## Staff Report

**To:** Development Review Board  
**From:** Michael Giguere, City Planner  
**Meeting Date:** March 26<sup>th</sup>, 2026  
**Subject:** Design review for the new residential construction at 40 Maple Street in the Residential 2 (R2) district by Ron Bushey, owner.  
**File:** SP# 6.2025.2

Figure 1: South elevation. Left: Submitted site plan; Right: As-Built Photograph.

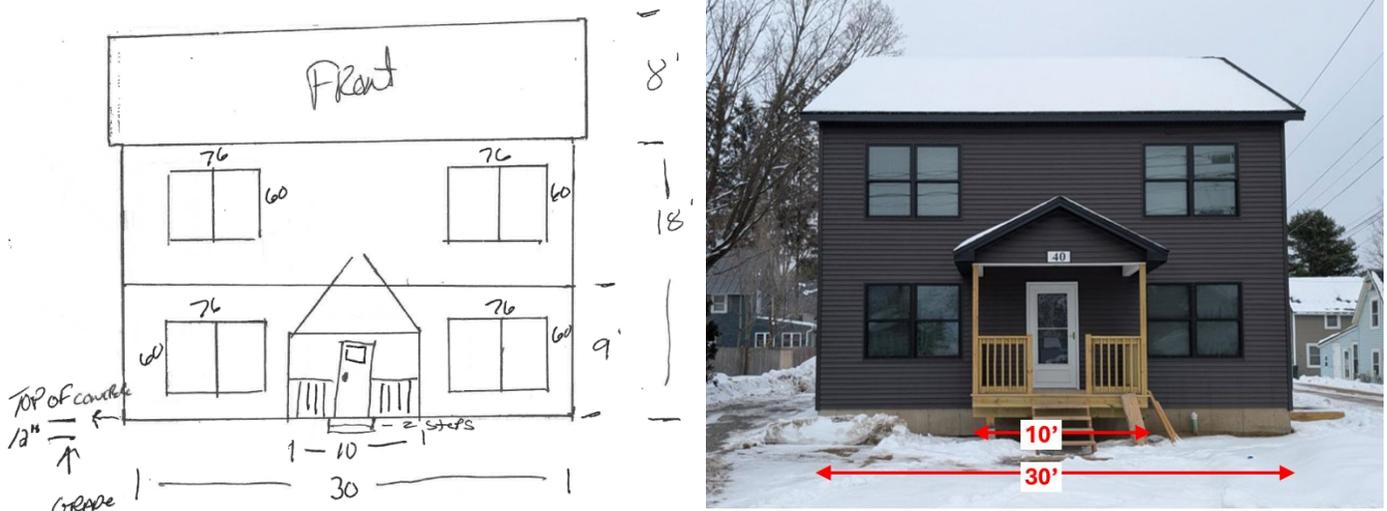
- Second-floor porch:
  - Approved: 6' x 16', right-justified on the rear elevation
  - Built: 5' 9" x 11' 6", centered on the rear elevation
- Rear door: shown as double; constructed as single.
- Missing second-story window at the northeast corner.
- Incorrectly-sized first-story window installed on the western side.

**The DRB should review the as-built plans and determine whether to approve the deviations from the August 2025 plans.**

Figure 5: Top-down site plan. Left: Submitted site plan; Right: Amended Site Plan based on as-built measurements. Note: Driveway, walkway, and landscaping have not been completed.

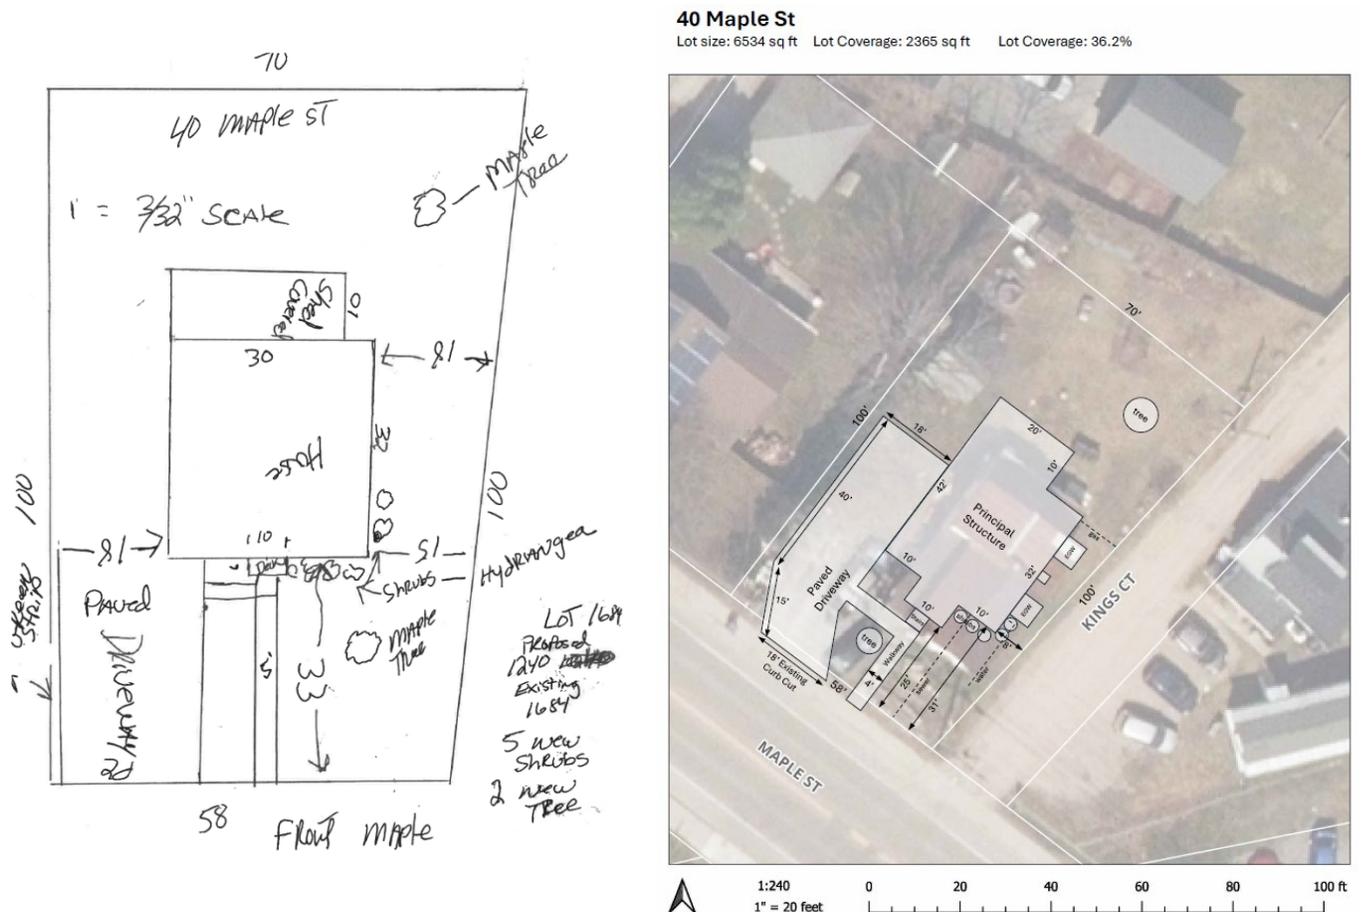
The as-built structure includes basement egress windows and associated window wells (5' 9" x 5') that were not shown on the previously approved elevations or site plan. Based on field measurements, the window wells appear to be located less than 8 feet from the side property line, placing them within the minimum side setback.

- Installation of rear steps.
- Landscaping has not yet been planted and has been adjusted to avoid utility conflict.
- Exterior light fixtures are not currently dark-sky compliant.
- Heat pump unit is not shown on the site plan (affecting lot coverage calculations).
- Driveway and walkway are not yet paved; the applicant proposes paving in the spring when hot mix asphalt is available and has reconfigured the proposed driveway orientation.
